Addendum 03

PROJECT: Fairfield Elementary School Office and Support Area Improvements
2825 Fairfield Avenue
Fort Wayne, Indiana 46807

PROJECT #: 25066.02

3 PS.1 NTS
SANITARY ISOMETRIC - UNIT B LOWER LEVEL

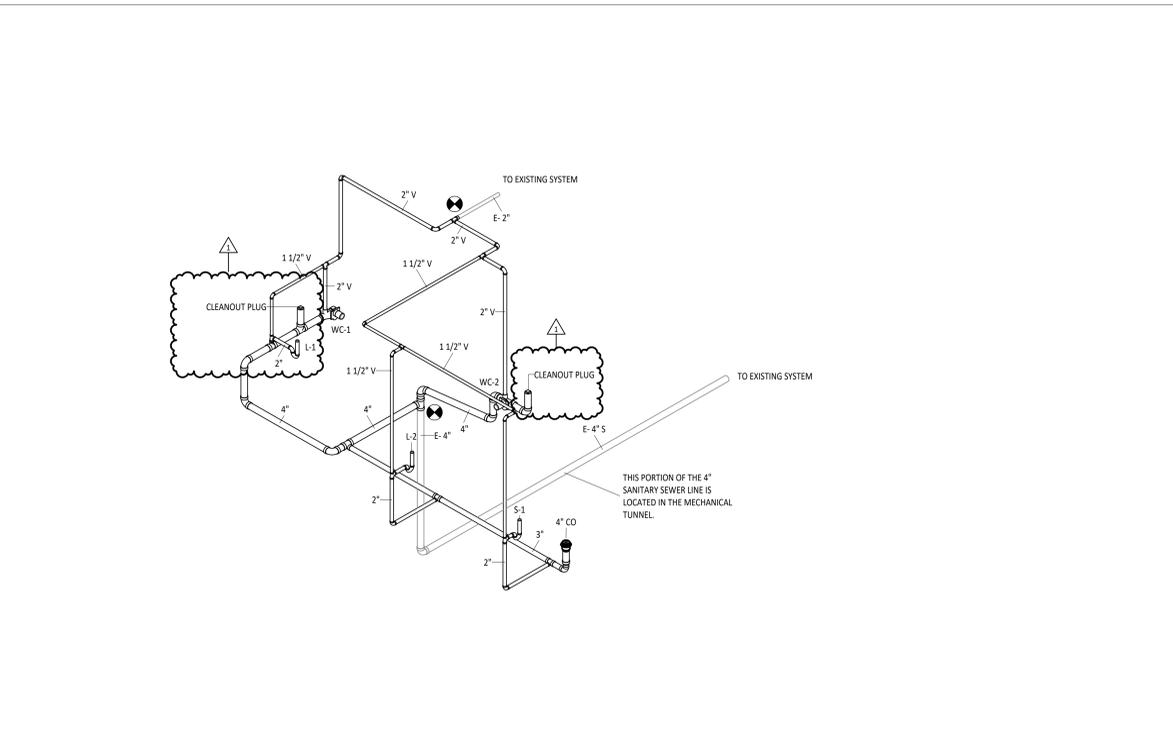
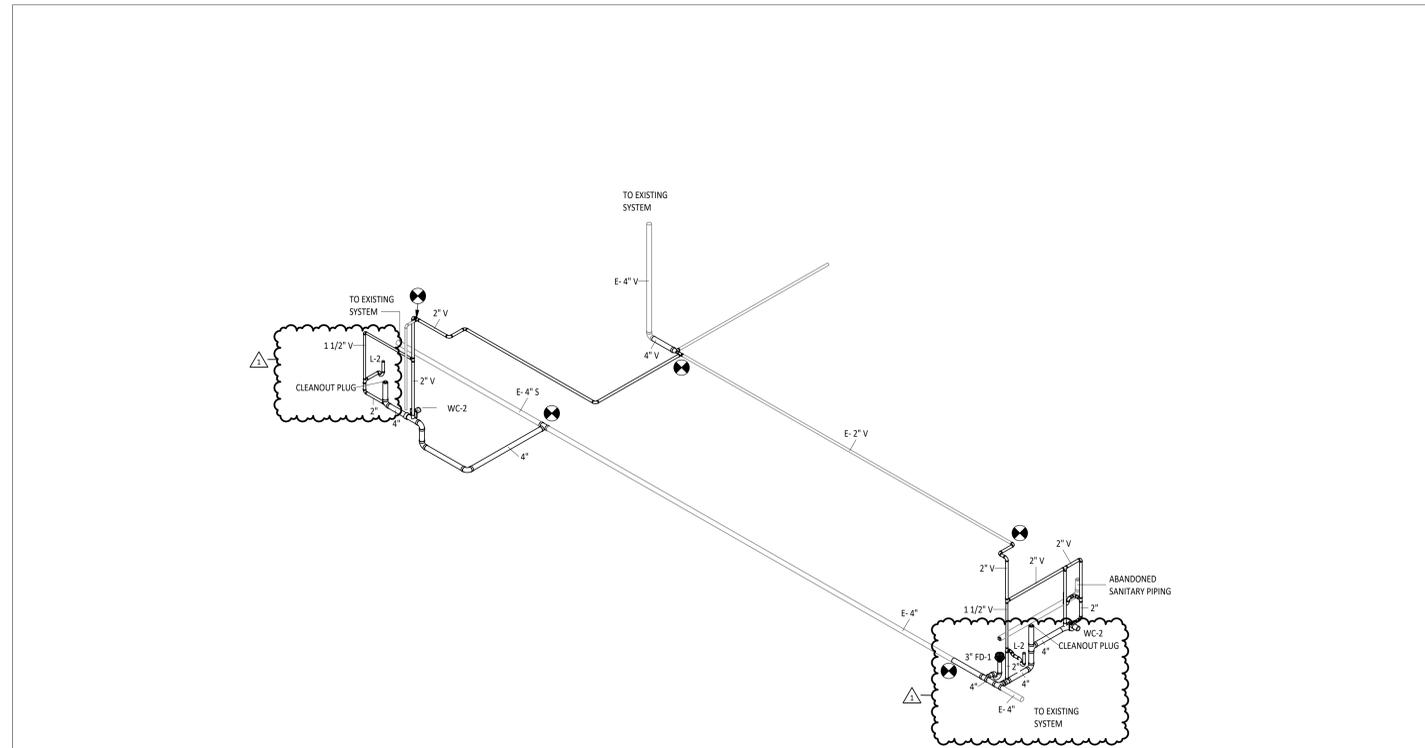
6. DRAWING SHEET P5.1 Plumbing Schedules, Details, and Isometrics
 - a. REVISE cleanout schedule quantities.
 - b. REVISE floor drain waste pipe size on the schedule.
 - c. REVISE sanitary isometrics to include the clean out plugs and new FD-1 location.
 - d. REVISE mounting height to 27" to rim for L-2.
